BOARD OF COMMISSIONERS
AGENDA
Monday, March 11, 2019 - 6:30 PM

RE: 415 Maplewood Avenue – Preliminary Subdivision Plan
David Semerjian Builders – Applicant

Preliminary Subdivision Plans – 415 Maplewood Avenue

Plans Prepared By: Edward B. Walsh & Associates, Inc.

Project- 4063
Date- 12-8-14
Scale- 1" = 30'
Drawn- R.F.N.
Checked- A.E.
Sheet- 1 OF 19

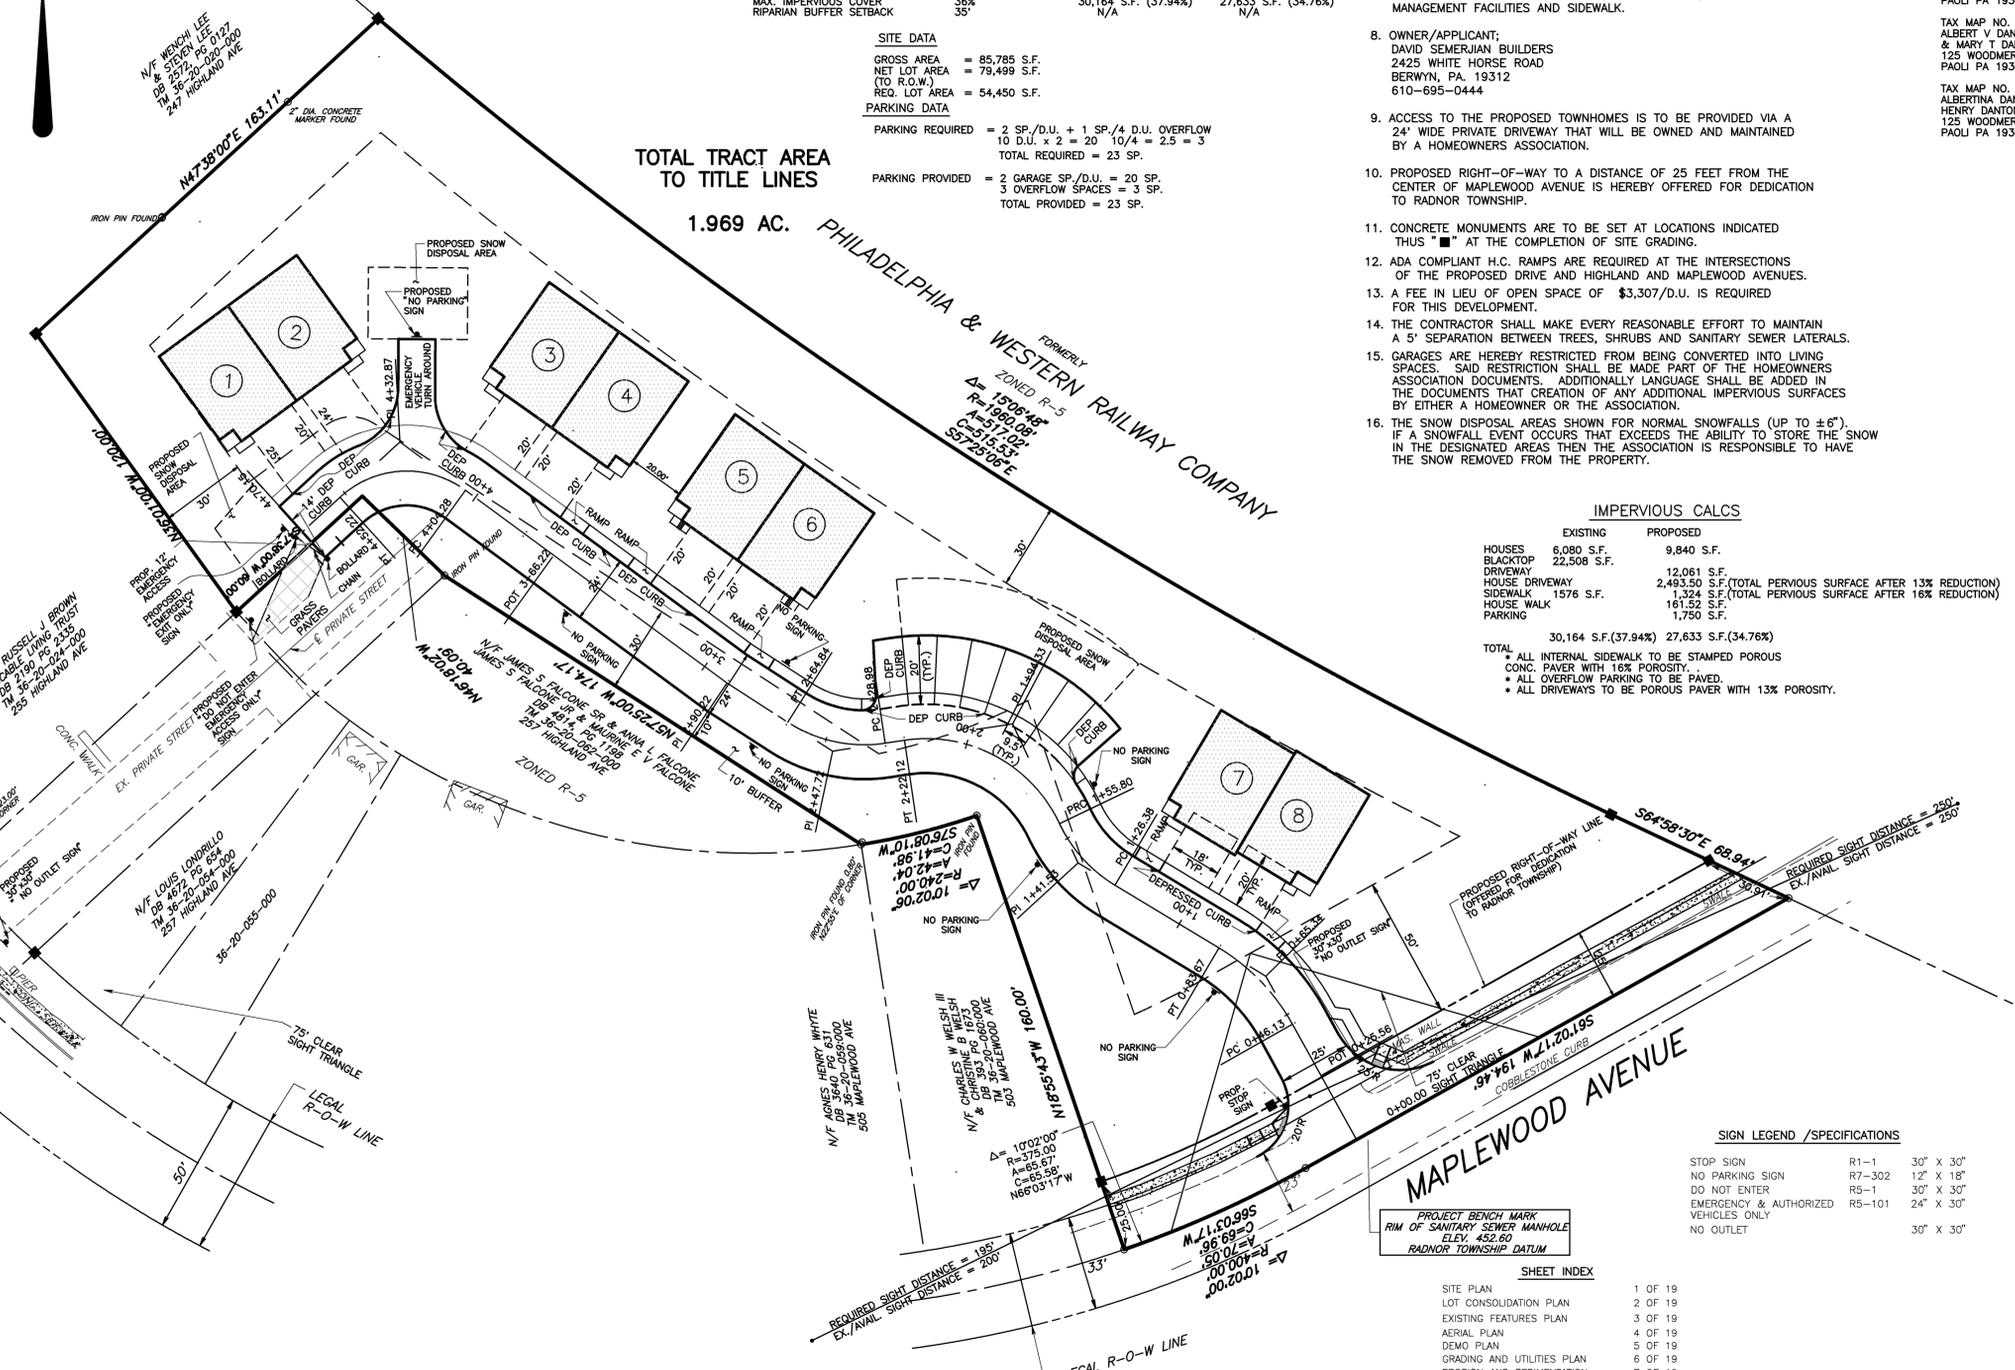
1. The legend on sheet 1 indicates a proposed retaining wall. If a retaining wall is proposed, it must be clearly shown on the plans.
2. The signature block on sheet 1 refers to Supervisors instead of Commissioners.

1. We have added a waiver request to sheet 1 of the plan set to permit the creation of a private driveway access for the condominium development we are proposing and a stub Private street that provides access to parking for two lots. Waiver request 5.

2. We have added a waiver request to sheet 1 of the plan set to permit the driveway and Private stub street without cul-de-sacs. We have also added proposed signs to both identifying them as not being through streets.

1. We have added sign details on sheet 18 and a description of each sign to sheet 1.
2. The relocated utility pole will have 1.5' of clearance. The graphics on the plan show the pole larger than it will be so it can be seen.
3. A No Parking sign has been added to the turnaround as requested.
4. See note 15 on sheet 1.

PRELIMINARY
GRADING AND UTILITIES PLAN

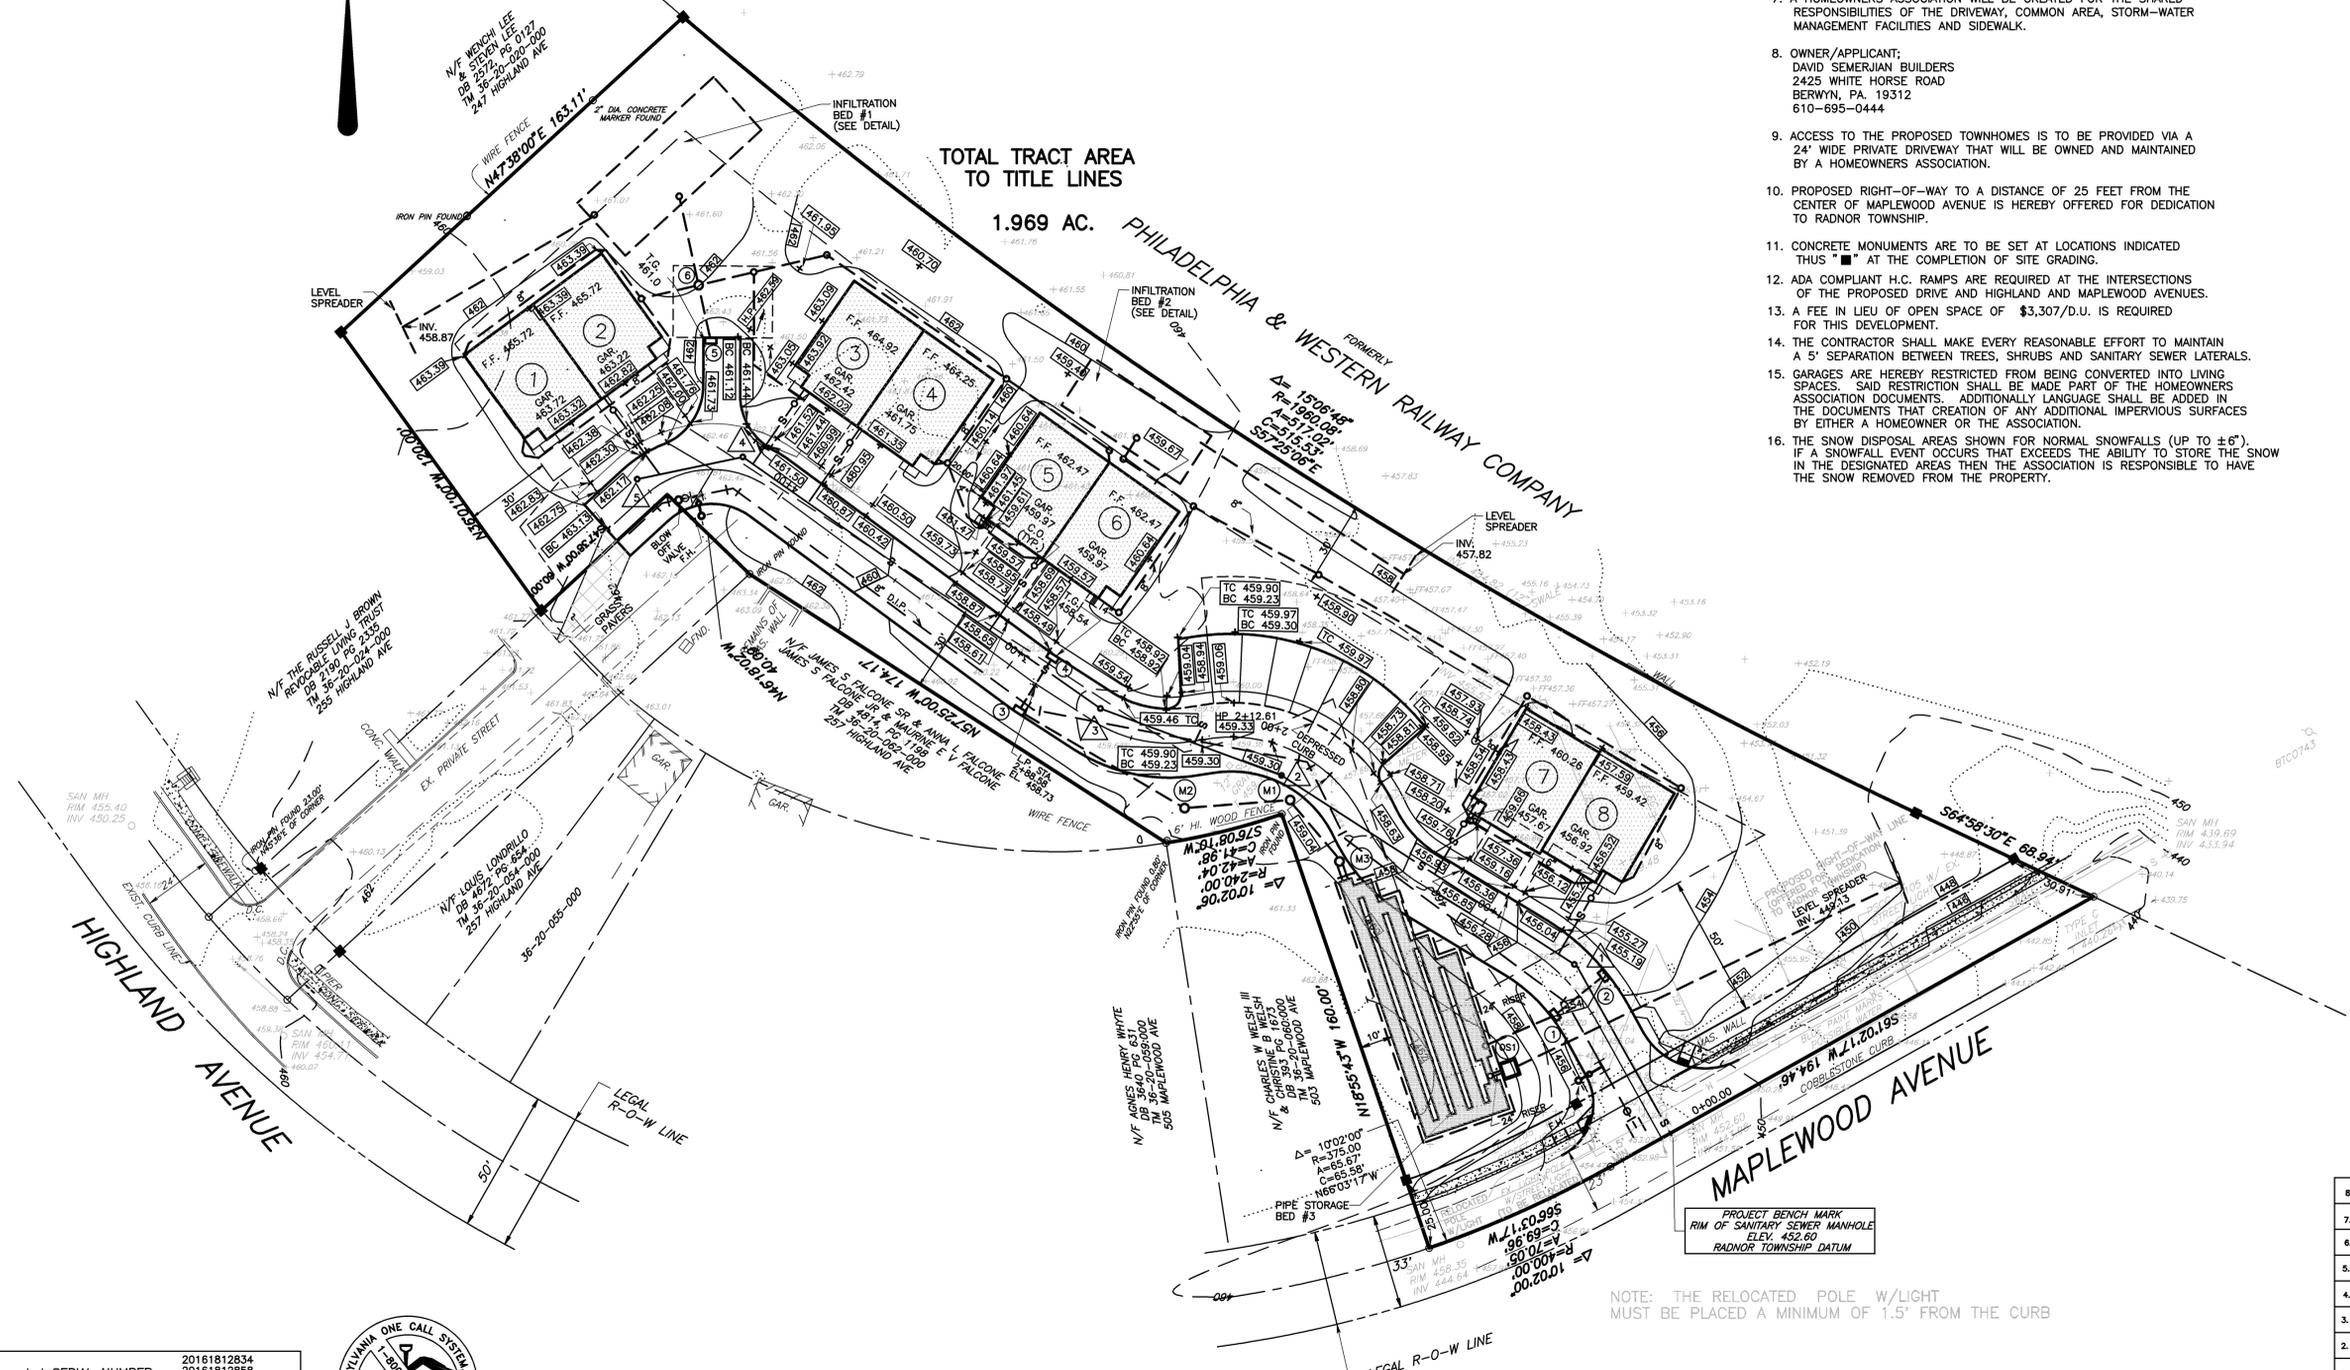
1. Provide details, including size, for all proposed signage.
2. Clearly label relocated utility poles and note the proposed relocation on both the preliminary plan sheet (sheet 1) and the grading plan sheet (sheet 6).
3. Sheet 10 of 16:
 - a. The internal driveway cross section detail appears to include a brick paver walkway and a 4' concrete sidewalk; update the detail to identify an ADA compliant sidewalk. Brick pavers are not ADA compliant.
 - b. Revise the profile for the proposed road to identify the centerline and right-of-way line for both Maplewood Avenue and Highland Avenue. Include the existing cross slopes of both Maplewood Avenue and Highland Avenue at their intersections with Central Avenue.

1. The Sanitary sewer manhole numbers have been added to the plan sheet 6.
2. The sewer profiles have been adjusted so that a minimum cover of 5' is provided on all the sewer lines.
3. We have added sanitary details to the plans.
4. All utility crossing have been added to the profiles.

PRELIMINARY POST CONSTRUCTION STORMWATER MANAGEMENT DETAILS AND PROFILES

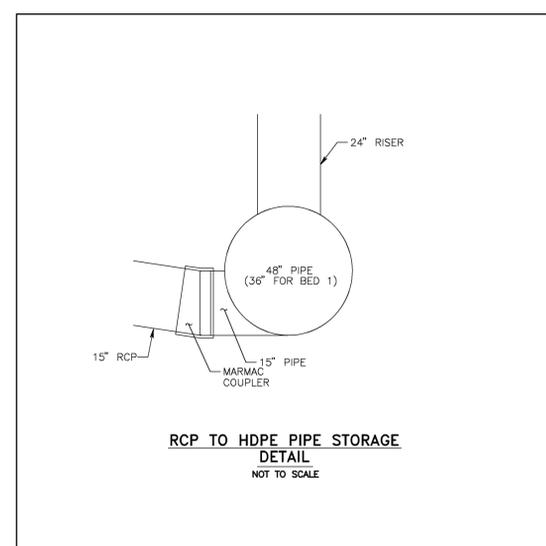
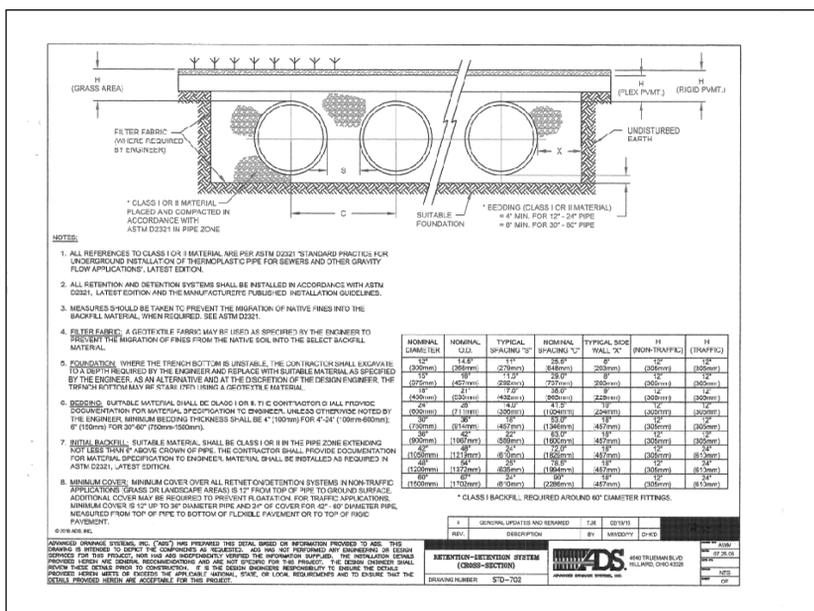
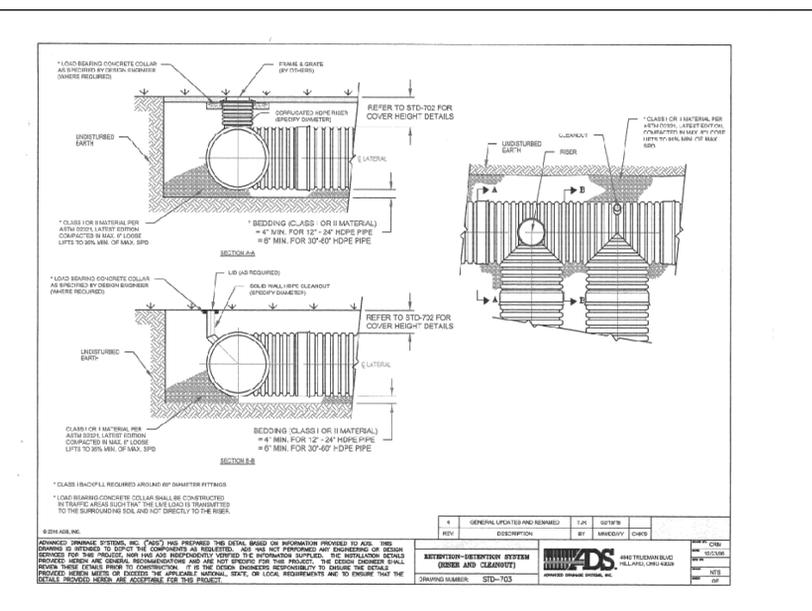
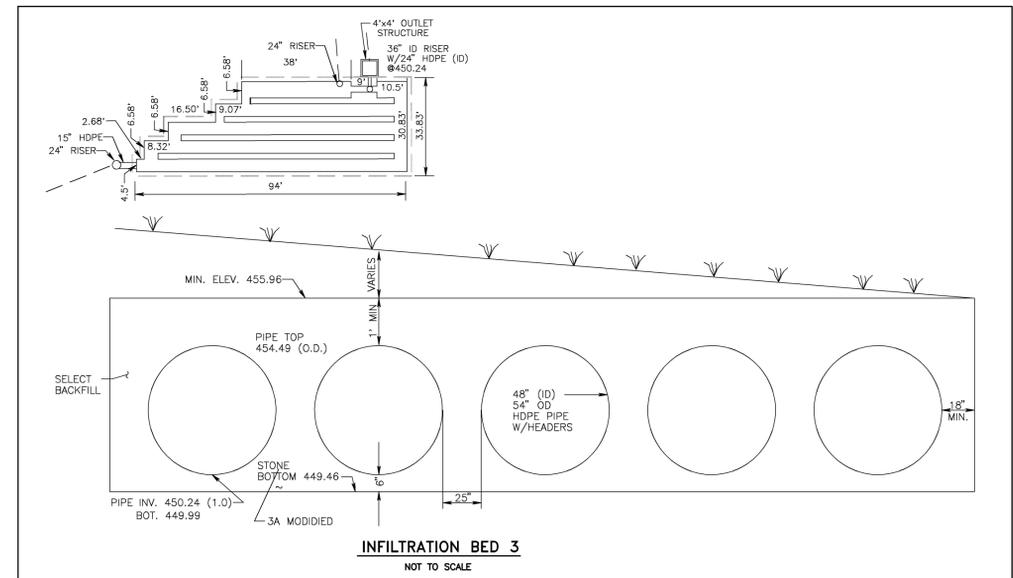
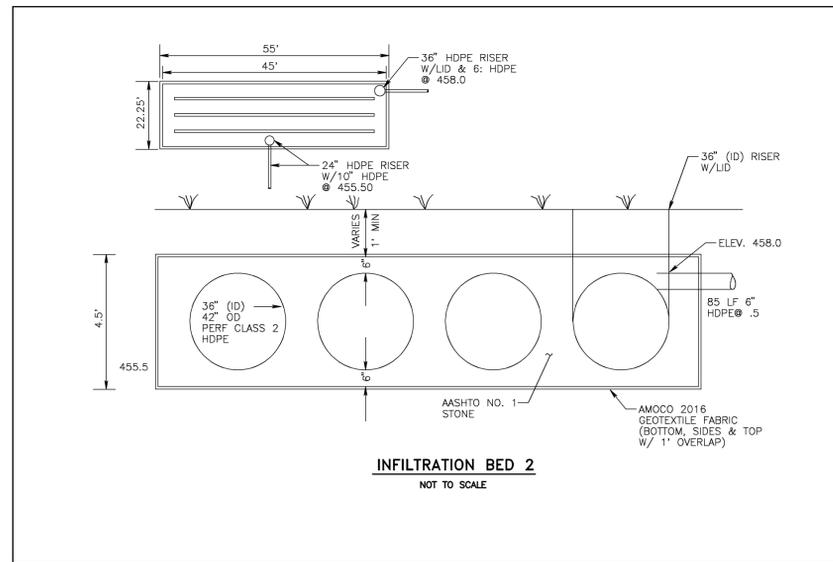
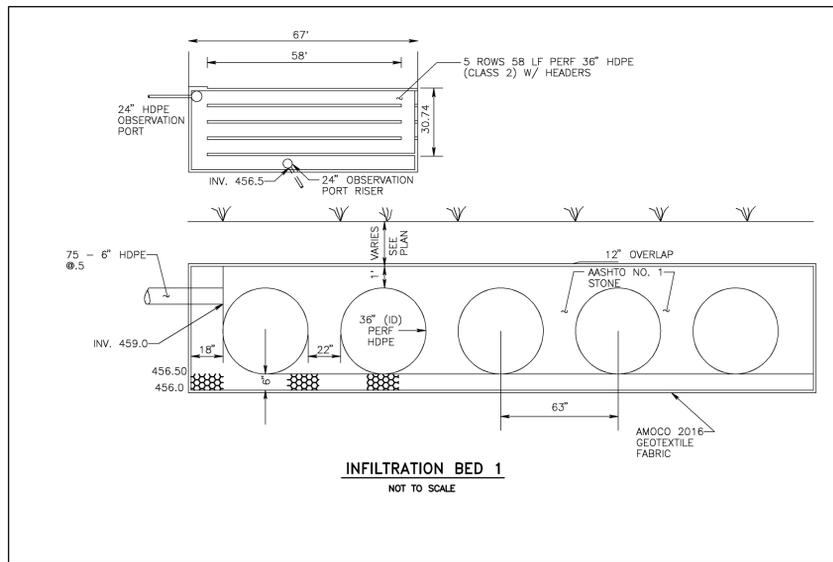
3. The Bed #3 Outlet Structure Detail on Sheet 10 and the orifice structures listed in the hydrograph (page 35) are not consistent. This inconsistency must be revised.

3. The applicant must show the water line crossings on the stormwater profiles on Sheet 10, specifically between Inlets #3 and #4, Inlets #1 and #2, and between Bed #3 and the level spreader.
